STATE OF NORTH CAROLINA
DEPARTMENT OF TRANSPORTATION

Addendum No. 1
RE: Contract # C204039
WBS # 34243.3.2
STATE FUNDED
Polk County (I-4729A)
I-26/US-74/NC-108 Interchange Modifications in the Town Of Columbus

September 19, 2017 Letting

The following revisions have been made to the Roadway plans:

1-AUG-2017 08:20
:\I-4729A\Roadway\XSC\I-4729A_Rdy_xpl.dgn
$$$$USERNAME$$$$

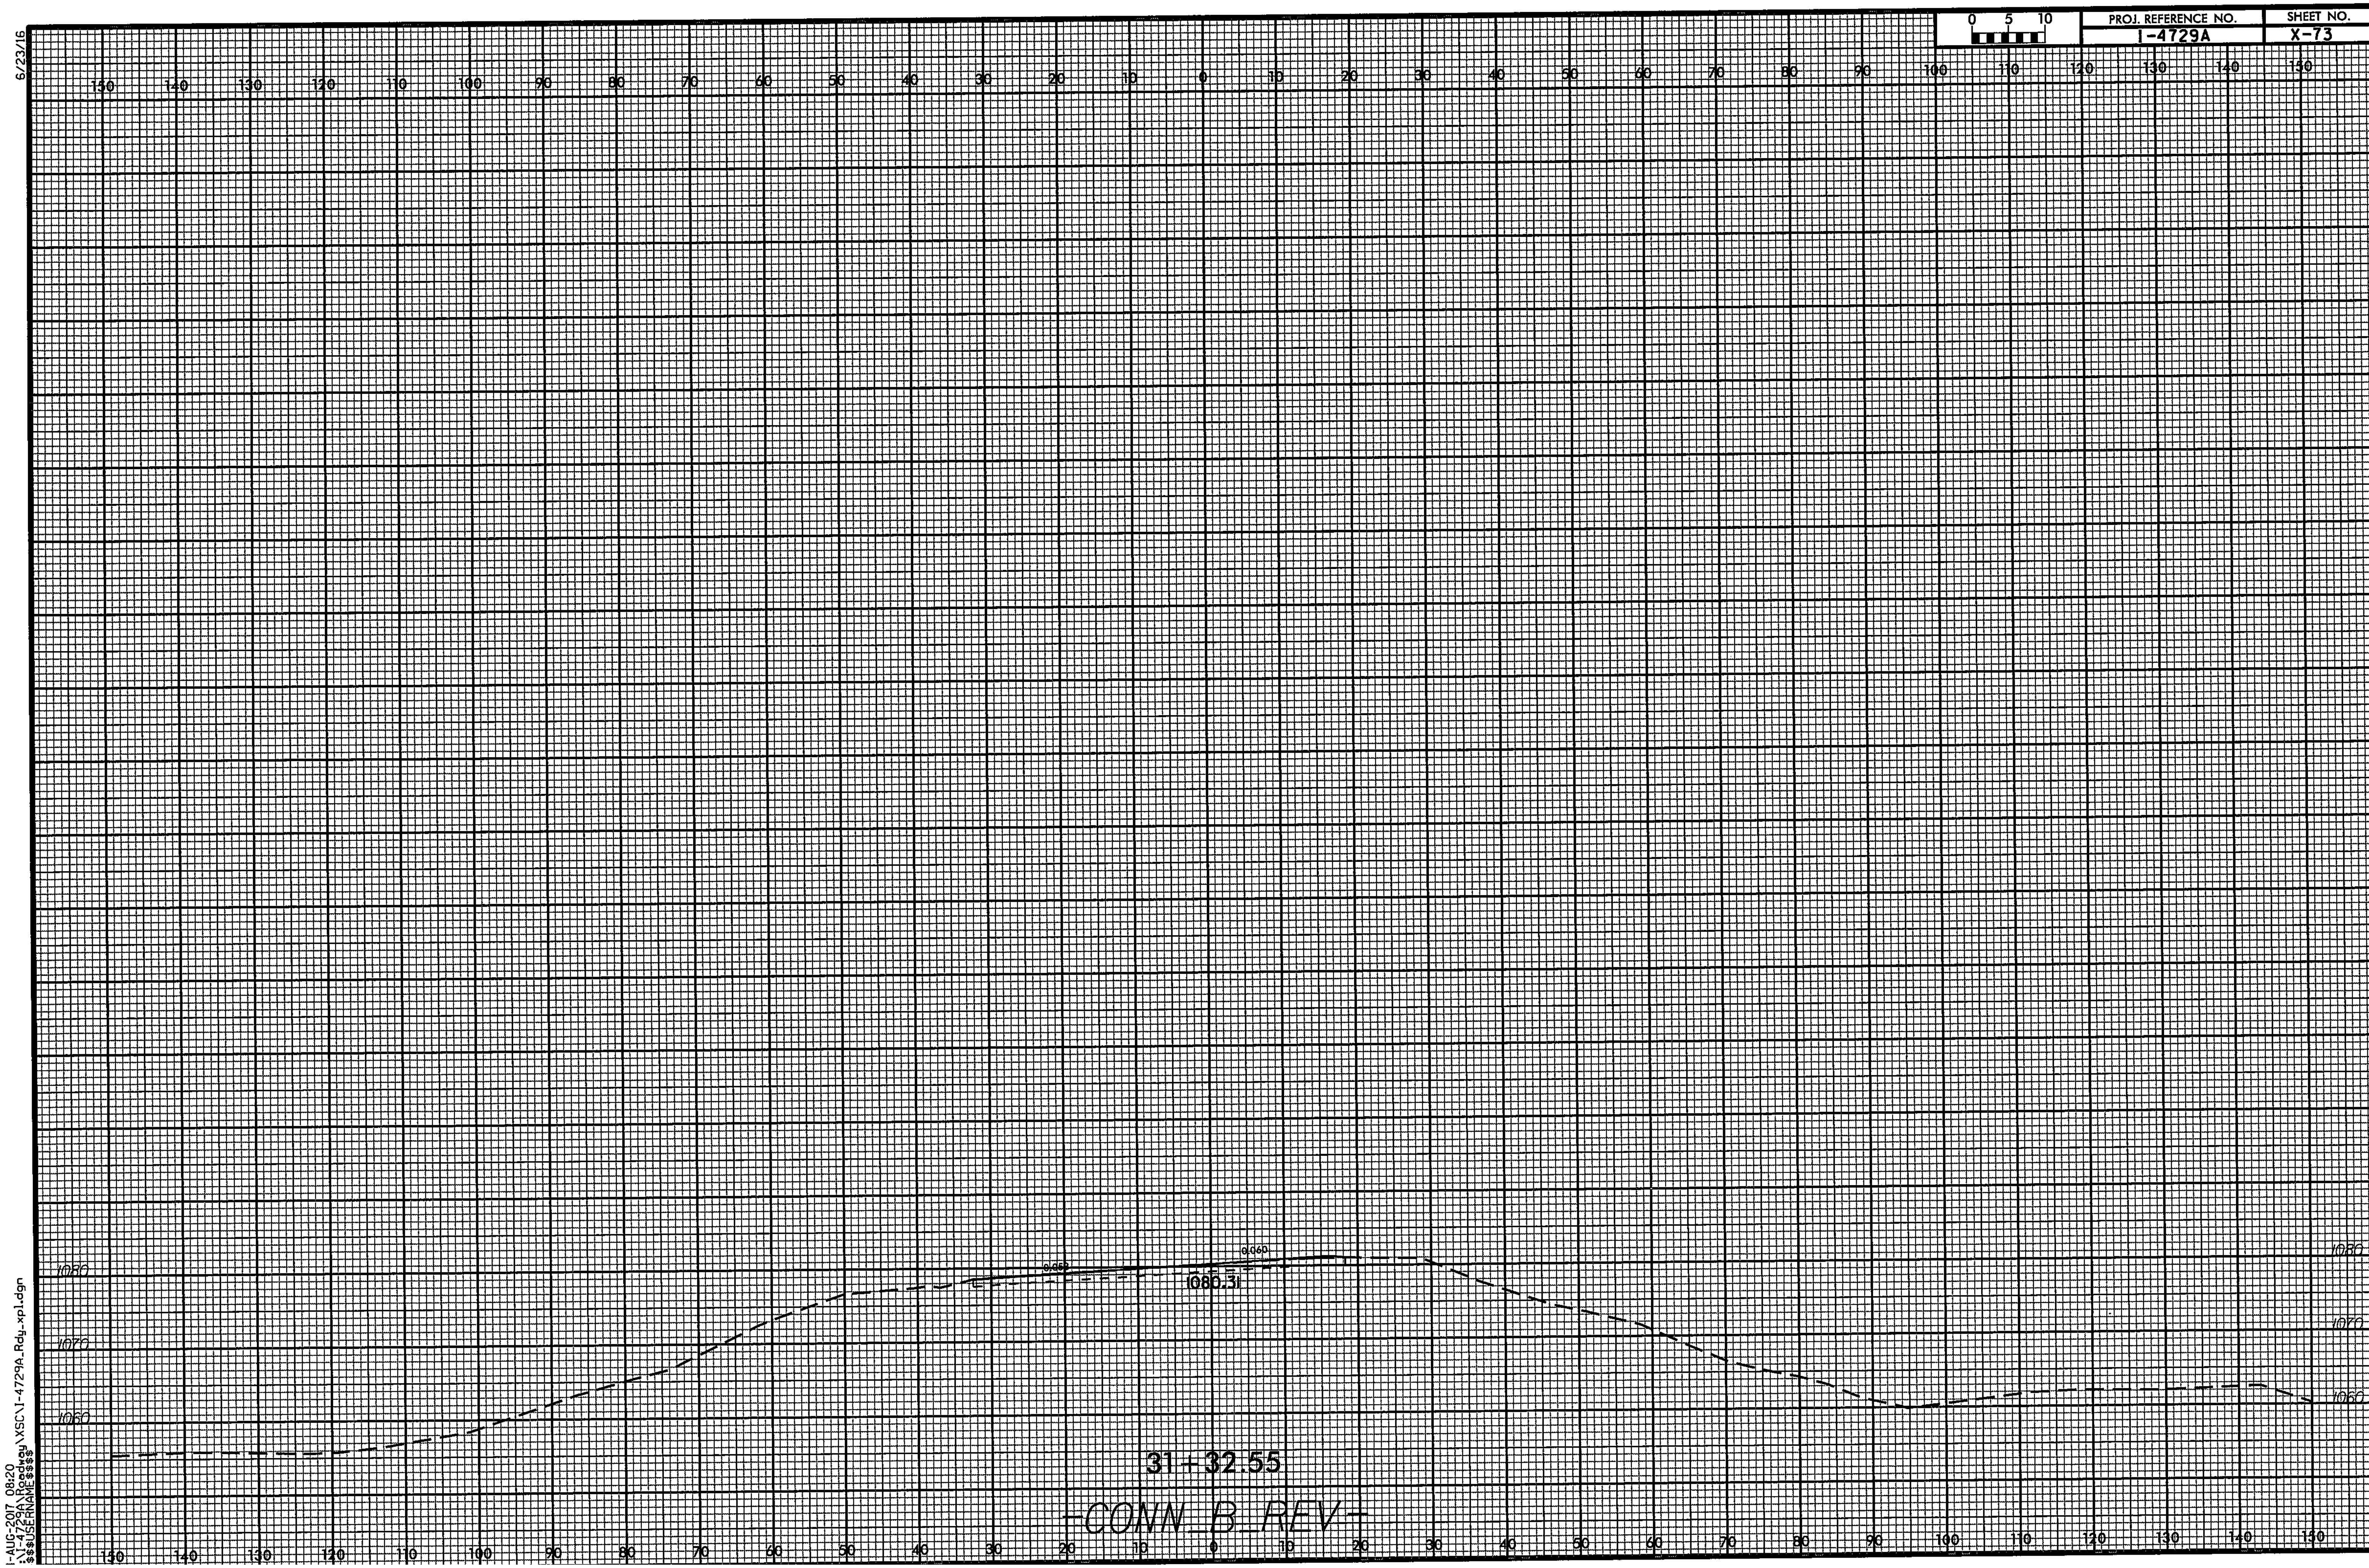
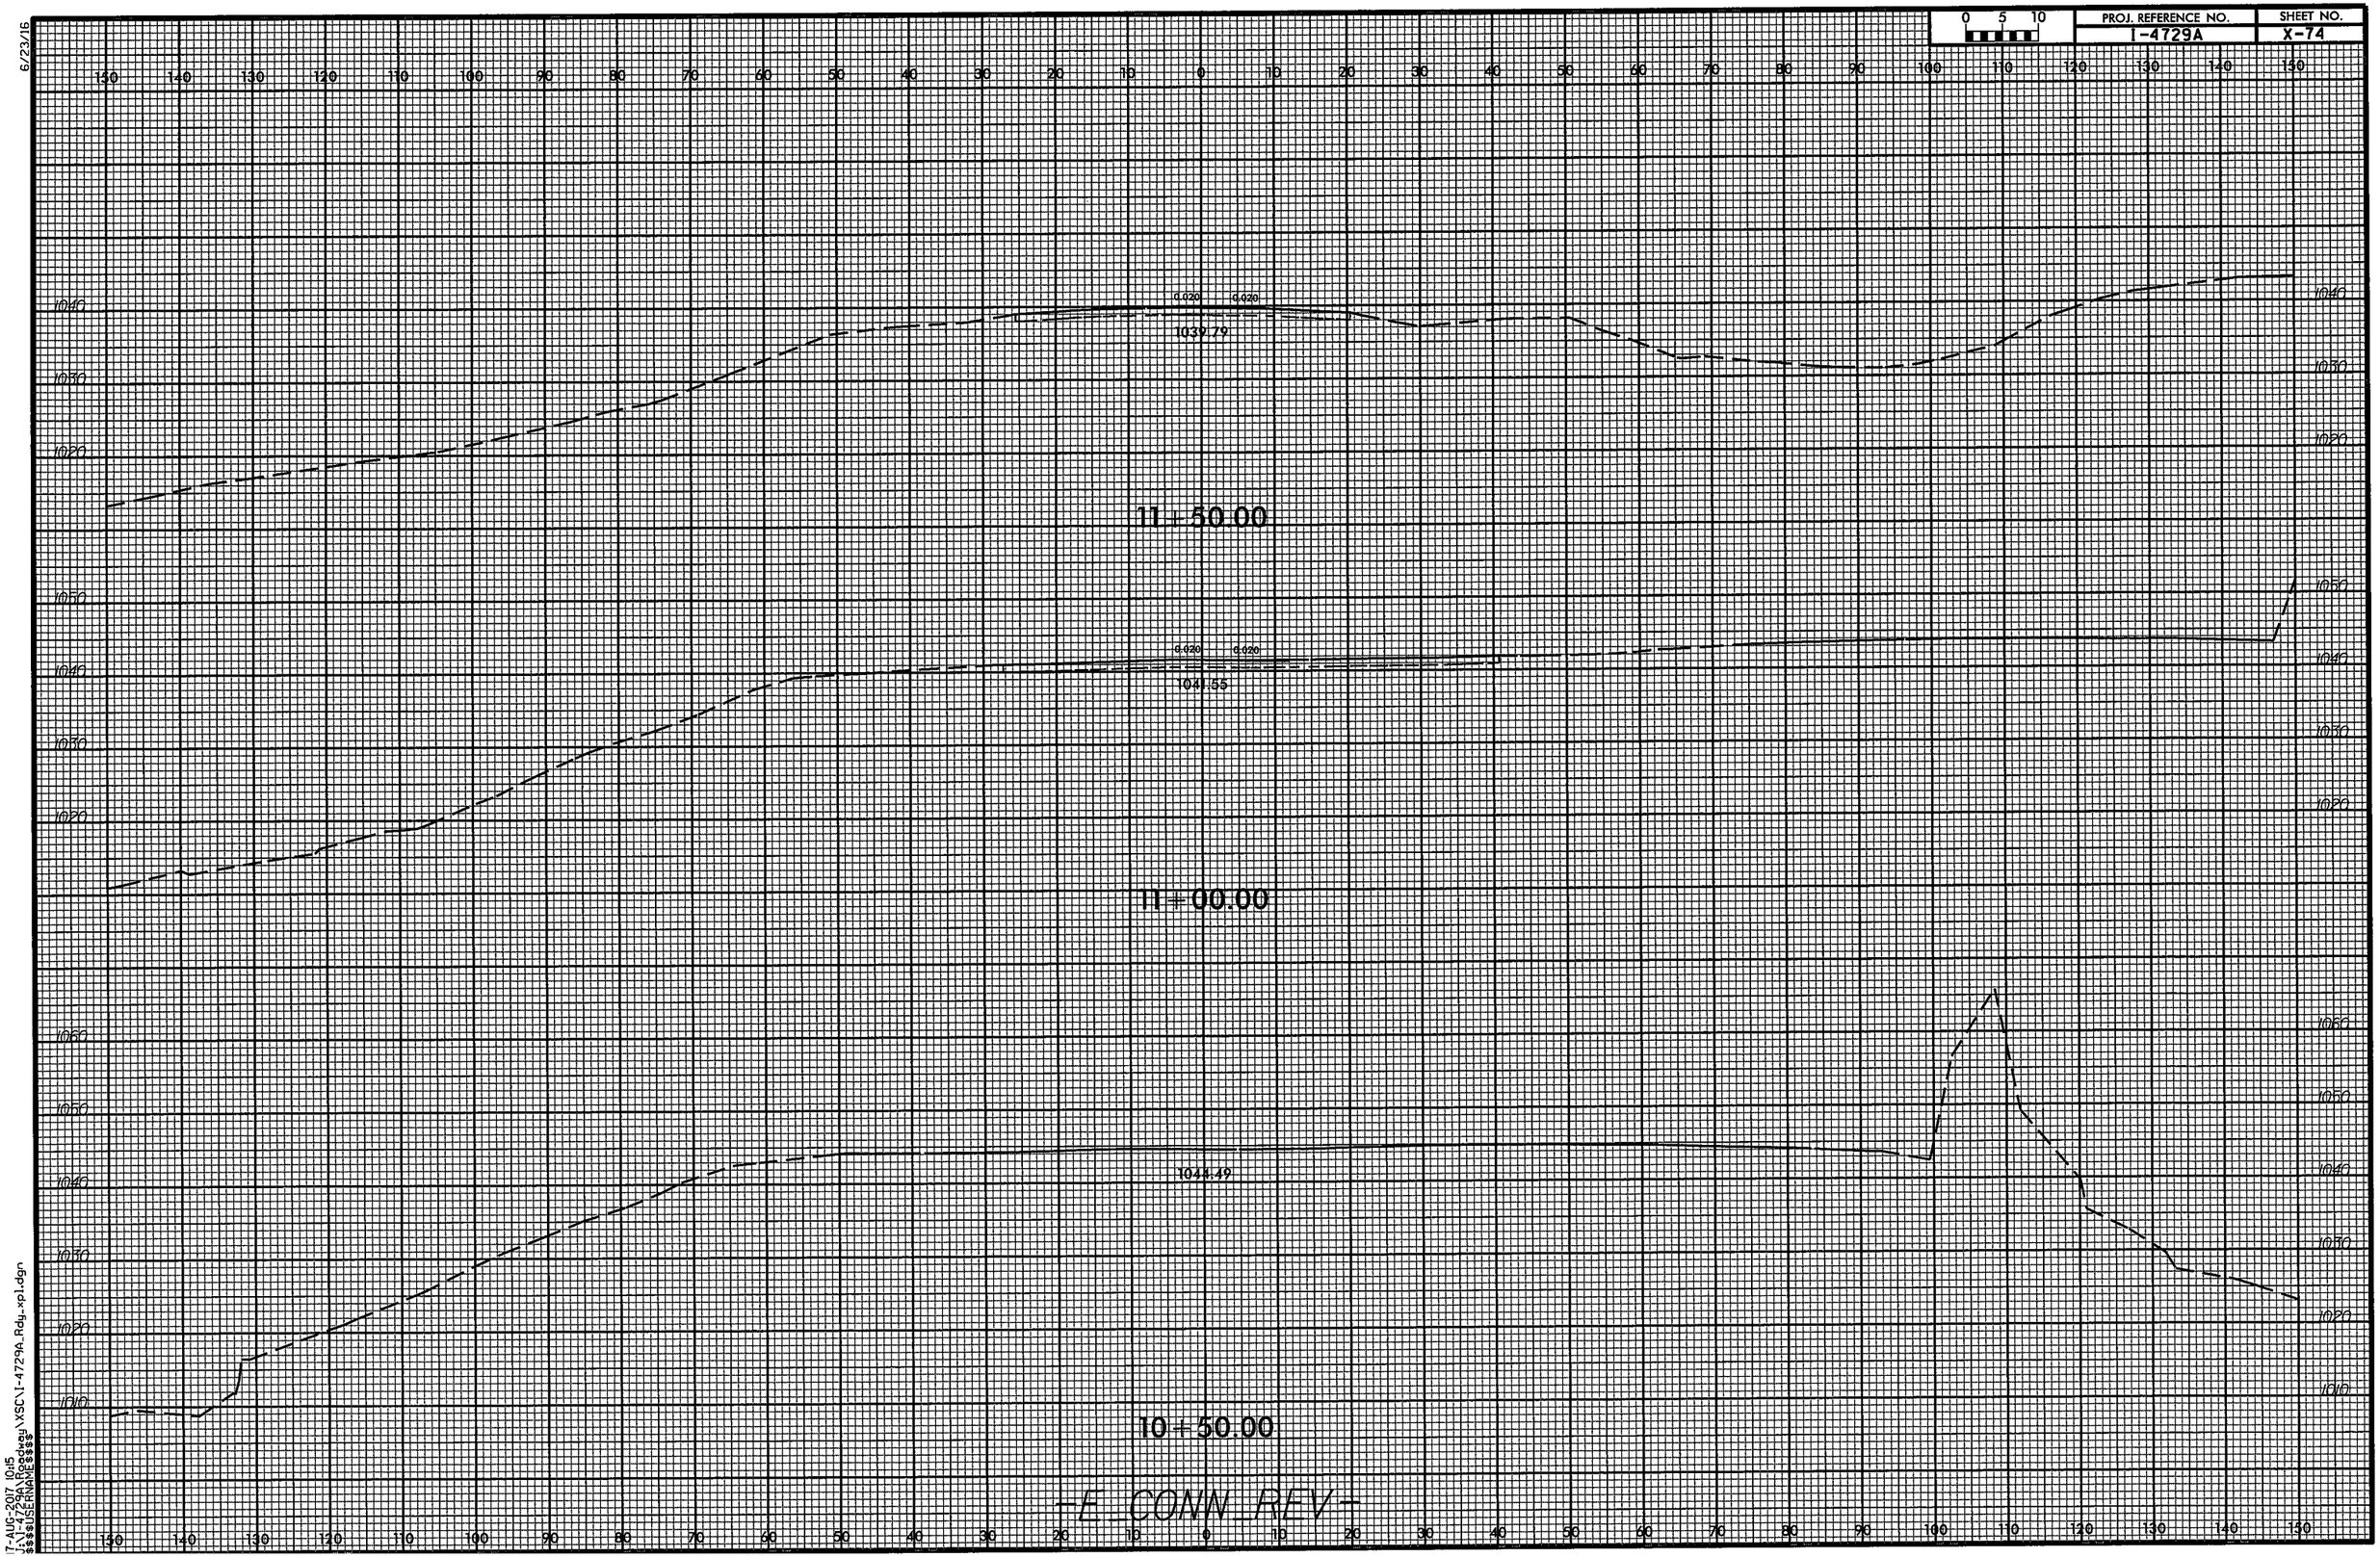
Sheet No.	Revisions
1A	Revised Index of Sheets to remove 2G-2 "Standard Embankment Monitoring Detail" and revise the number of" Drainage Summaries" sheets
2A-1, 2A-4 and 2A-5	Revised the Typical Sections for the change in mainline pavement widening design from ABC to Asphalt Base
3B-1	Revised 'Summary of Earthwork' to account for pavement widening design change
3D-1 thru 3D-4	Various drainage quantity changes as noted below
3G-1	Removed "Settlement Gauge Summary" and added note that Bridge Waiting Period only applies to Approach Slab construction
5	Revised to require Welded Steel Pipe by Trenchless method under the Interstate 26
X-1A thru X-87	Revised Cross-Sections to reflect the change in Earthwork due to the pavement design change
